MEMORANDUM

SUBJECT: Item 4.3, DA2021/2567 60 Federal Parade, Brookvale, St Augustine's School - Demolition work and construction of carparks and increase in student population.

REFERENCE: Applicants response to the NBLPP request for additional information

Extract from TPMP showing 143 car parking spaces

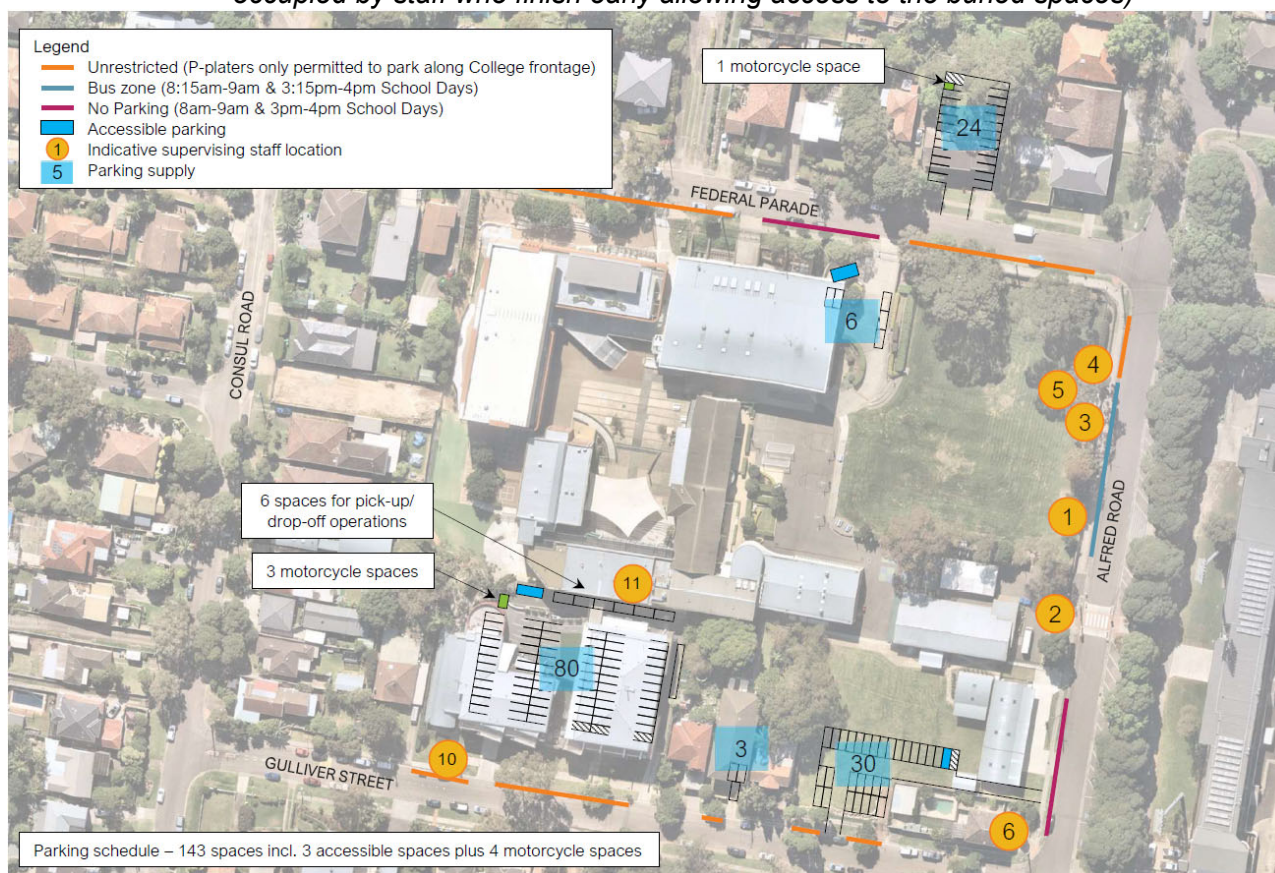
- (i) **Existing car parking** - Appendix 1 details the location of 143 off-street parking spaces (see screen shot below). Council's Transport Engineer inspected the site on Monday 1 May 2023 and confirmed the following:

There are 80 existing parking spaces in the Gulliver St carpark comprised of:

- 3 x rows of 12 spaces,
- 3 x rows of 11 spaces,
- 1 x disabled parking space,
- 6 spaces for drop off and pick up which are occupied through the middle part of the day by early finishing staff and 4 spaces running perpendicular to one of the 11 space rows (also occupied by staff who finish early allowing access to the buried spaces)

The plans shown in Appendix A of the TPMP are essentially correct. The box shown alongside the exit aisle is for 4 x parallel parking spaces. These spaces are not however located alongside that aisle as the facilities manager confirmed it is too narrow for this to occur. The spaces are, instead, located alongside the next aisle to the west. See images on the attached document. This is however deemed acceptable if the spaces are vacated early to allow access to the spaces buried behind which, it was confirmed, is what occurs in practice and works from a school operational point of view.
